Preliminary Consultation
MONTGOMERY COUNTY HISTORIC PRESERVATION COMMISSION
STAFF REPORT

Address:	7228 Spruce Ave., Takoma Park	Meeting Date:	5/27/2020
Resource:	Contributing Resource Takoma Park Historic District	Report Date:	5/20/2020
Applicant:	Paul Landefeld and Christine Dobridge (Richard Vitullo, Architect)	Public Notice:	5/13/2020
Review:	Preliminary Consultation	Tax Credit:	No
Case Number:	N/A	Staff:	Michael Kyne
PROPOSAL:	Building addition and window replacement

PROPOSED
SIDE ELEVATION
1/4" = 1'-0"

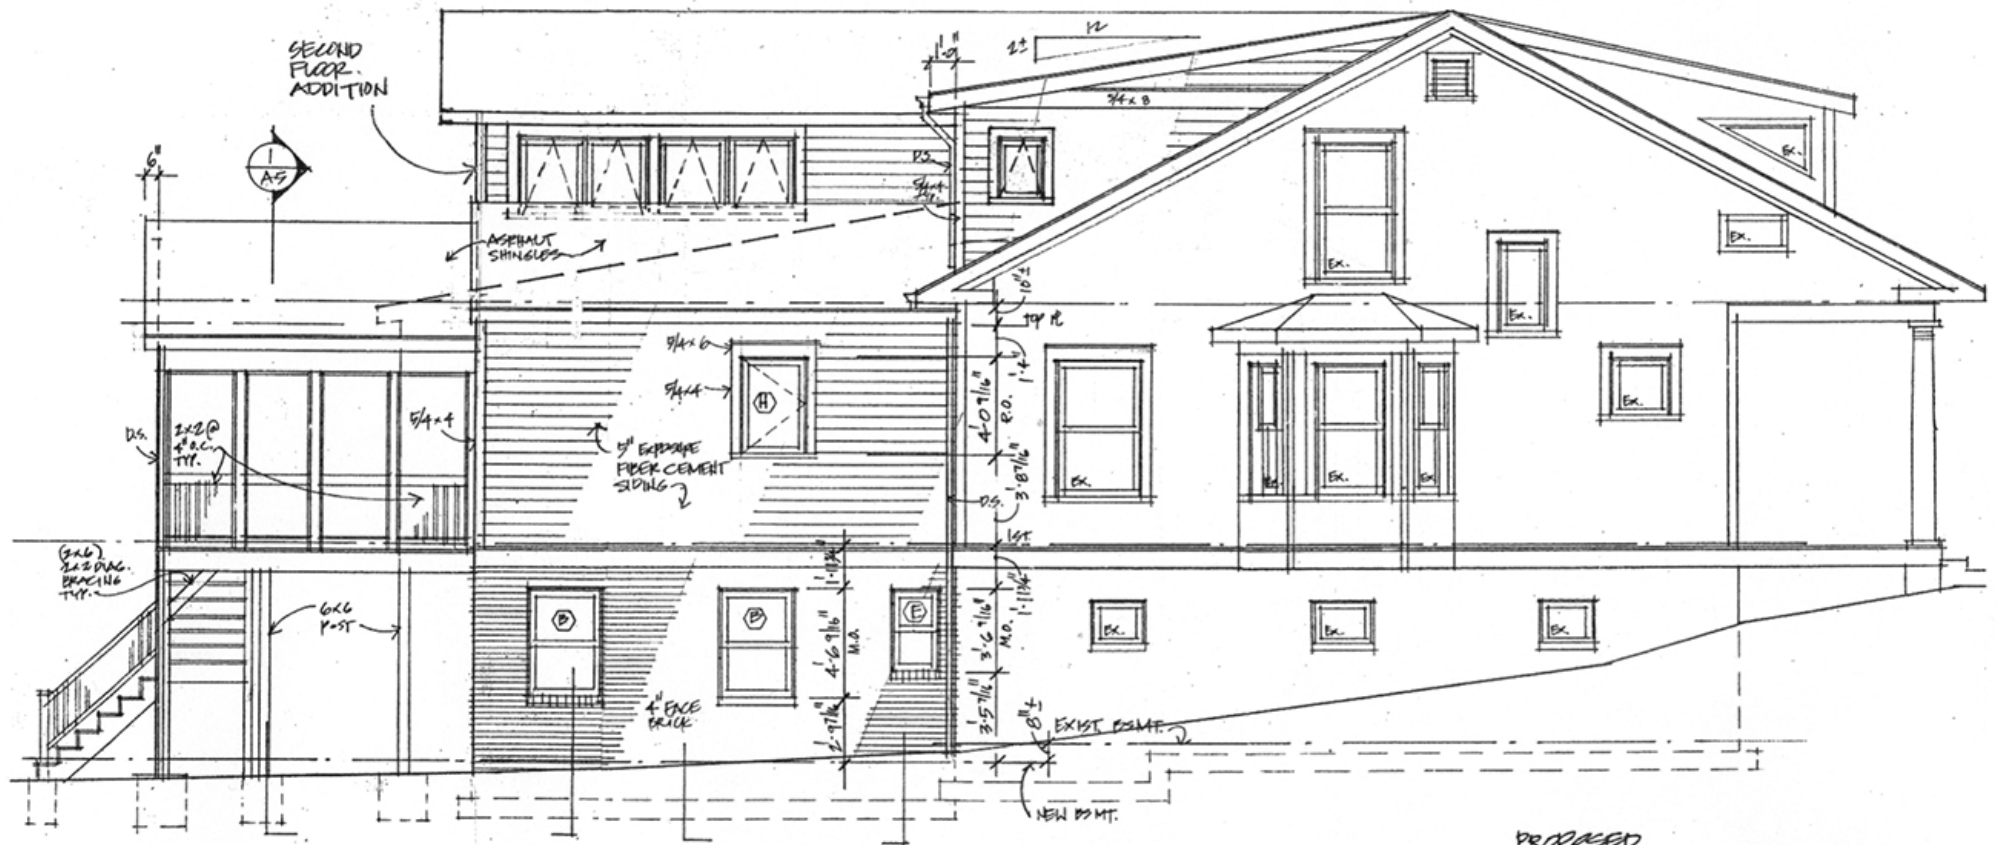
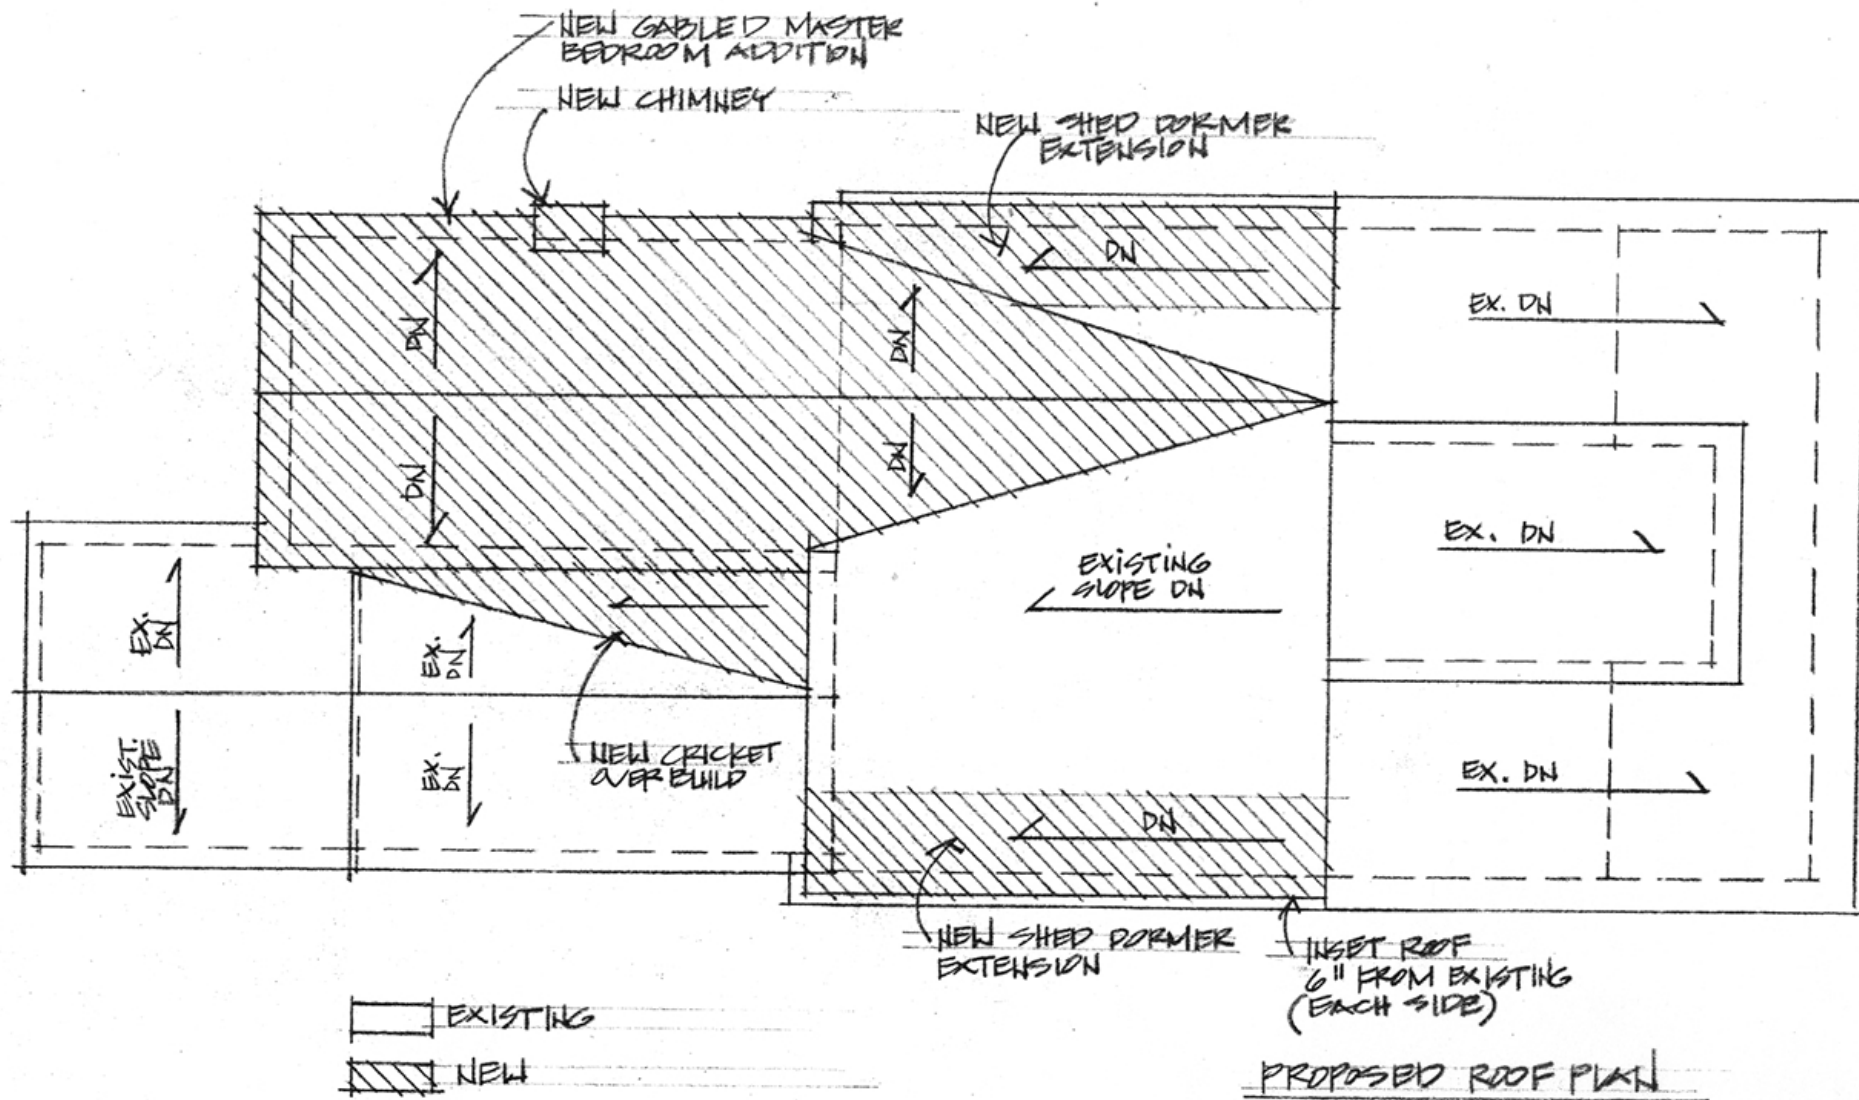
- Staff is concerned about the proposed fiber cement-clad chimney on the north (right) elevation of the additions. Staff finds that a clad chimney is incompatible with bungalow-style architecture, and it has the potential to detract from the historic house and surrounding streetscape. Staff recommends a traditional masonry chimney or interior chimney, in order to achieve compatibility. Staff does acknowledge that, although the proposed chimney will project slightly beyond the north (right) elevation of the historic house, the house's siting may limit the visibility of the proposed chimney from the public right-of-way of Spruce Avenue. Staff asks the Commission to take this into consideration in making recommendations for appropriate revisions.

- Staff is also concerned about the proposed cricket overbuild. Although this will mostly affect the roof of the 2007 shed dormer addition (and its visibility from the public right-of-way, like the chimney, may be limited), staff finds that the proposal results in a complex roof plan, which is incompatible with the relatively simple roof plan of the historic house.

- Staff finds the proposal to replace the small wood casement window on the north (right) elevation of the historic house with a new wood casement egress window is generally inconsistent with the *Guidelines* regarding the preservation of original window size and shape. However, the *Guidelines* state that original window size and shape should be preserved where feasible, and staff argues that it is infeasible to preserve the size and shape of the window in question, due to egress requirements. Staff also finds that the visibility of this window is limited from the public right-of-way.
